SIPS Coffee Hut

Site Plan

Planning Commission Meeting
August 3, 2023

Case Number: 23.02 SKC

SITE SKETCH
SIPS COFFEE
MILLS, WYOMING

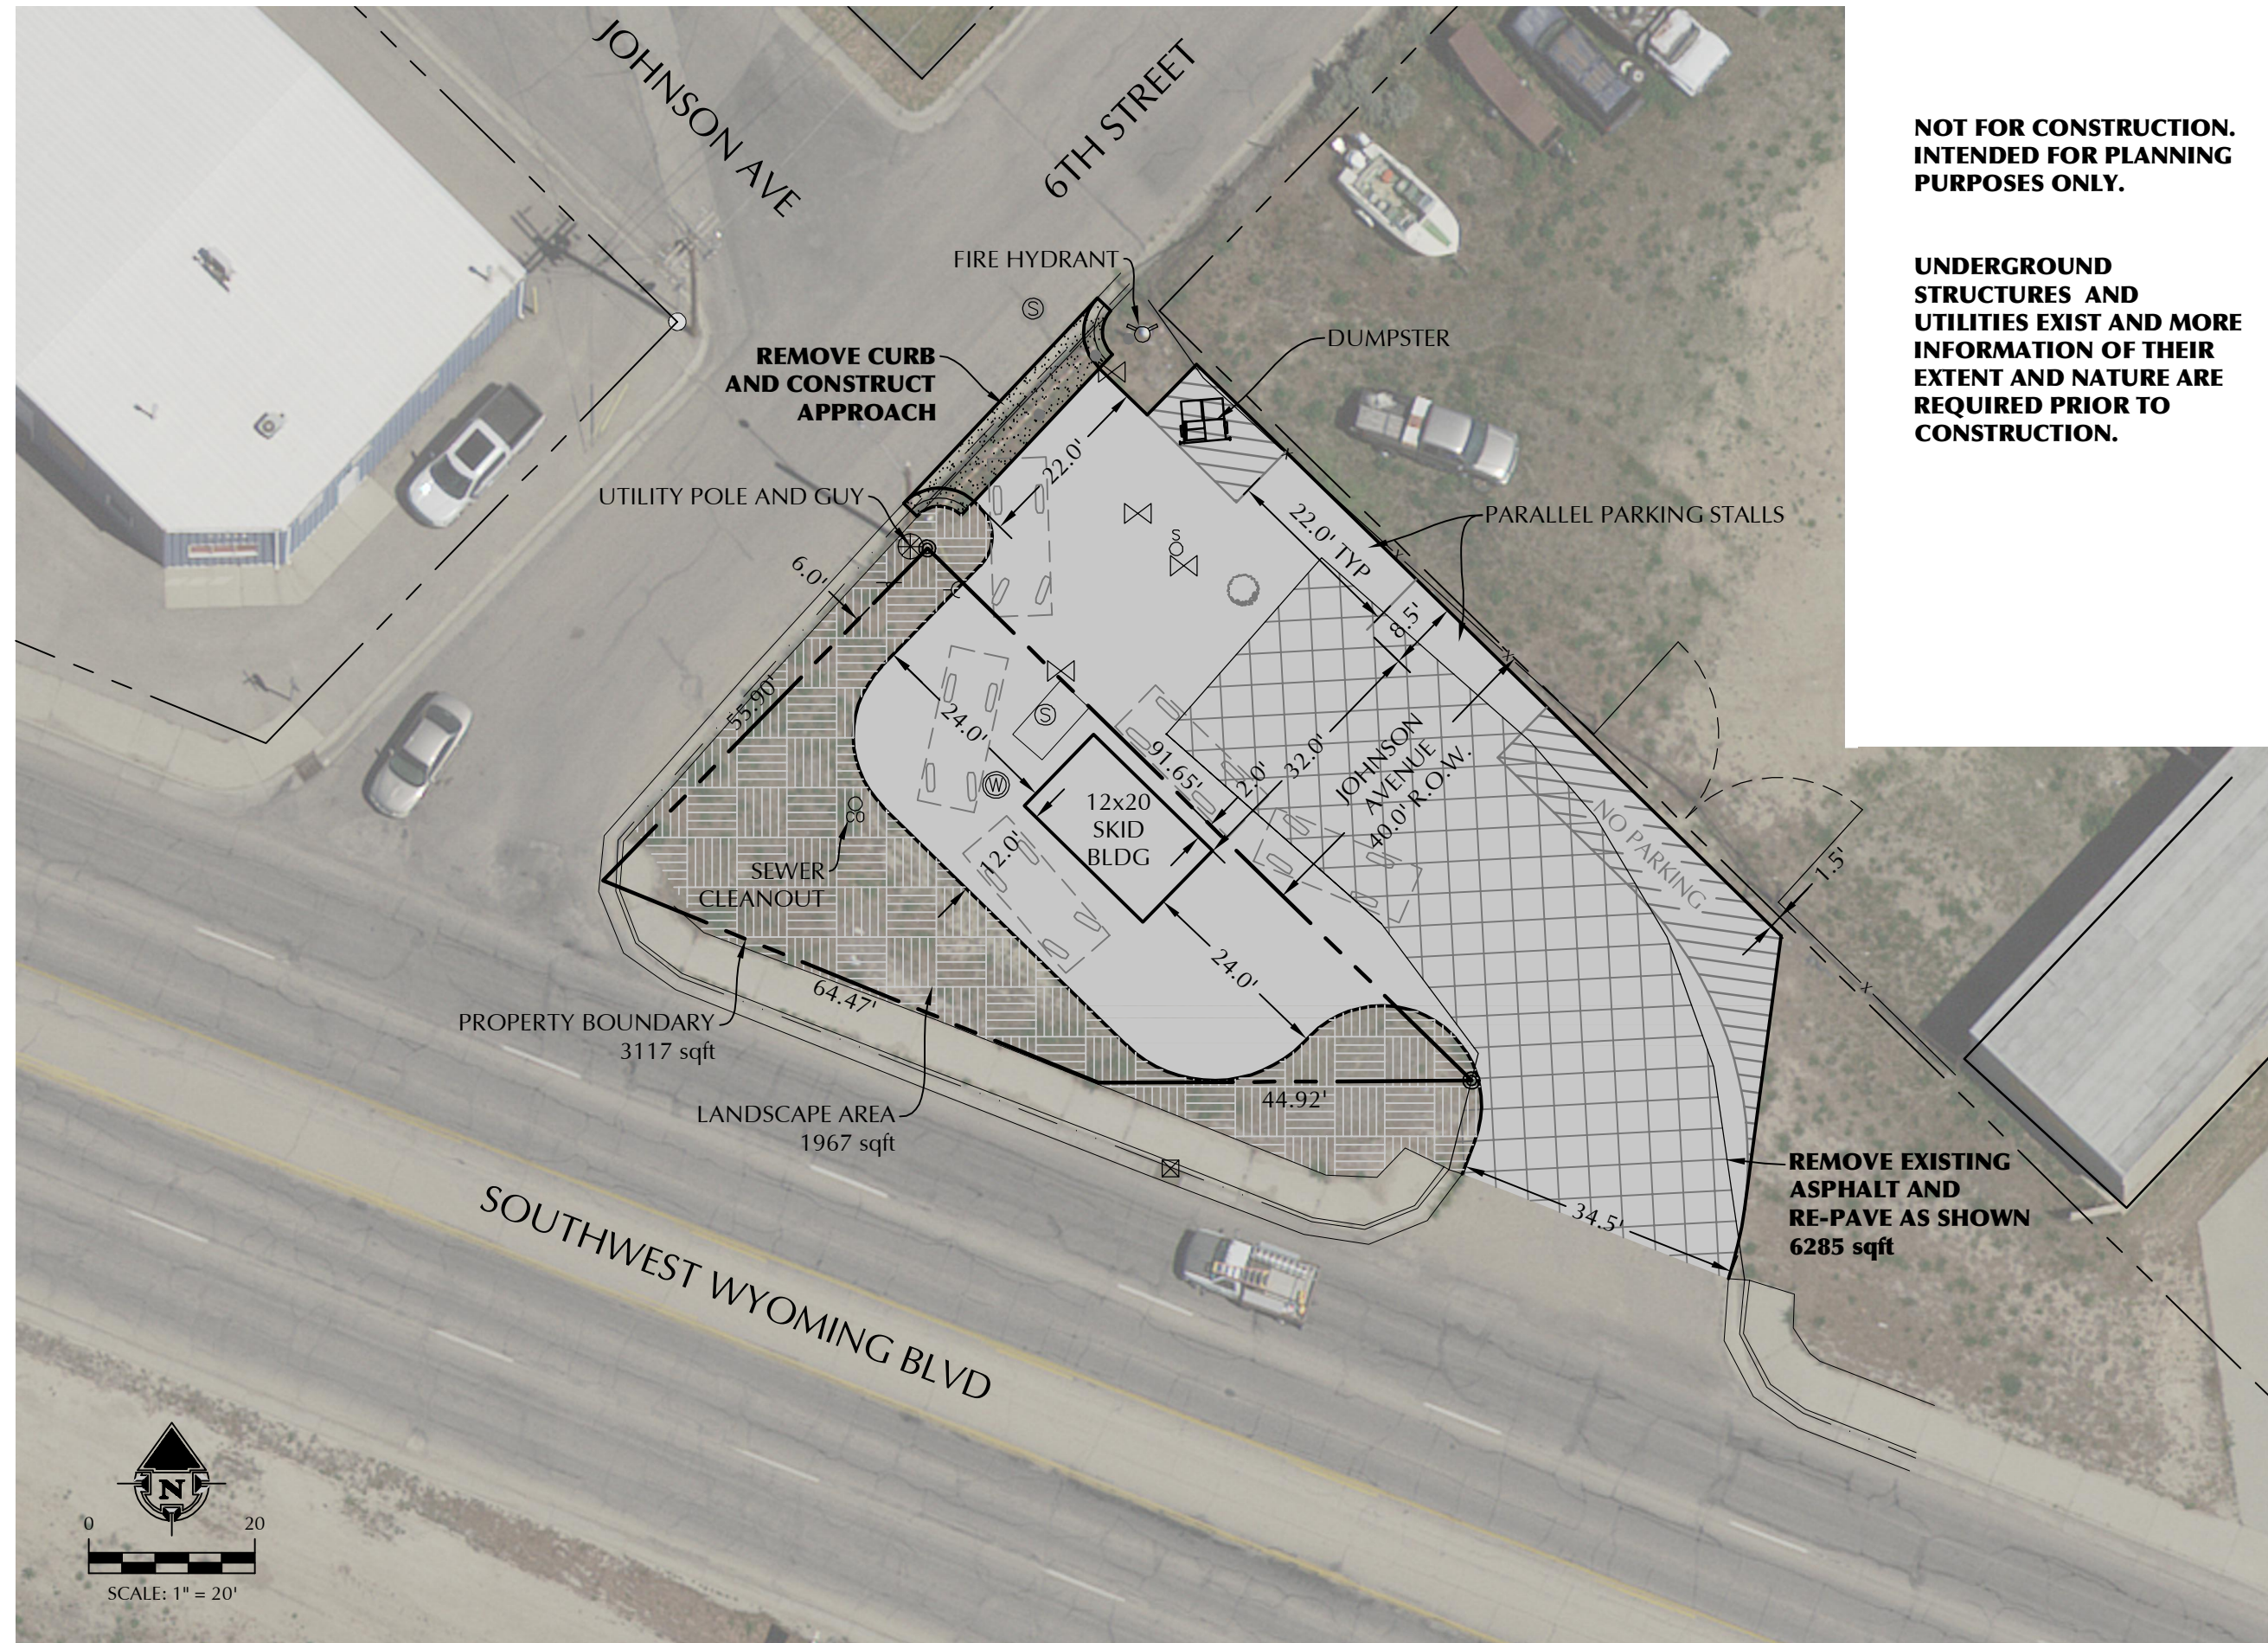
1. Reduction of the required parking from five (5) stacked vehicles at each drive-up window.
 - a. The applicant must show area for five (5) vehicles, stacked at each drive-up window, or shall request a waiver from the City Council.
 - b. The waiver must be submitted at least 14-days prior to the City Council meeting, to allow for notification of surrounding property owners, per Section 17.12.010

- a. Revise the site plan to show space for five (5) spaces for stacking vehicles at each drive-up window.
 - b. No additional parking is required as there is no floor area used for assembly or seating.
 - c. The applicant may submit a waiver request, to be heard and acted on by the City Council, for a reduction of the number of required parking spaces.
4. Per WYDOT, no new access permits are required for the proposed use.
 - a. Applicant may not let traffic back up onto Wyoming Blvd. from Johnson Avenue.
 5. Provide a summary table on the site plan that includes all general notes as required in item 21 of the Site Plan Application Checklist.
 6. Label each item on the site plan to the corresponding requirement in the Site Plan Application Checklist.
 7. Submit a pavement design report.
 8. Submit a sign permit for any signage to be placed on the property.
-
